SERVICE BULLETIN 405 4 CYCLE

ISSUED: April 1997

SUBJECT: OHV16 thru 17 Falters Due To Lean Fuel Mixture (With fuel shut-off solenoid)

MODELS AFFECTED: OHV16 thru 17 Specification Nos. 204216D, 204217D, 204224D, 204228D, 204604A, 204605A, D.O.M. (Date of Manufacture) Affected 6280 - 7091 Located on ID Tag.

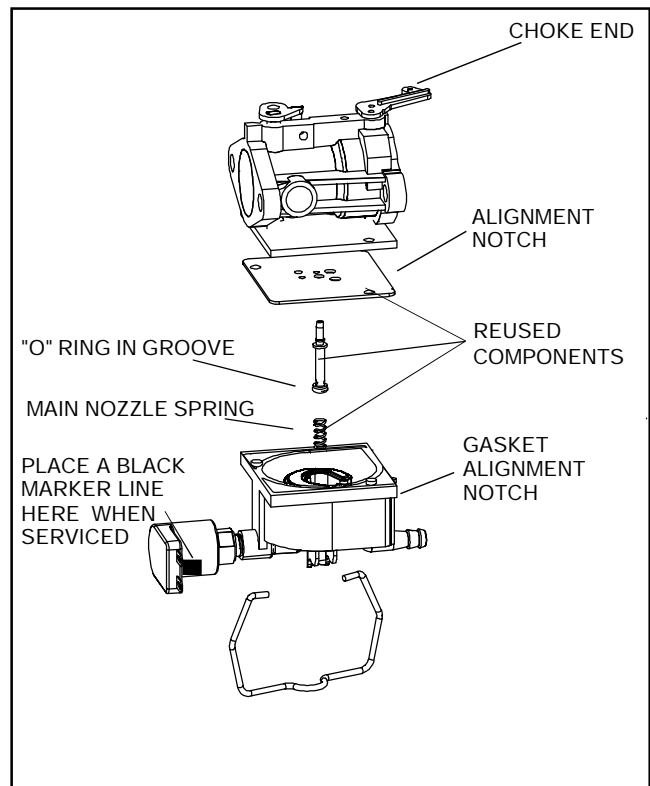
We have received field comments regarding faltering or a lean condition on OHV16 thru 17 HP engines equipped with fuel shut-off solenoids. The manufacturers affected are Ariens and MTD products.

The engineering department has investigated this concern and verified this could occur after 20 - 30 minutes of warm up under the following conditions:

1. Winter/Spring fuel blends which are sensitive to warmer temperatures.
2. Under no load or light cutting conditions.

Install the bowl kit with transferred parts as noted in Item 6 above. NOTE the gasket has a notch which lines up with the "V" mark on the fuel bowl. The bowl must be reinstalled as shown with the locating pins properly engaged into the carburetor body. To identify repaired units look for or place a permanent black magic marker line across the flat steel portion of the solenoid facing out as shown. (See Illustration)

If you receive a customer comment regarding this condition please order carburetor bowl kit Part No. 730624. To minimize any possible mis-assembly, the kit will include a complete bowl assembly less the main nozzle tube, nozzle spring and gasket. These parts are to be transferred from the old bowl assembly to the new one.
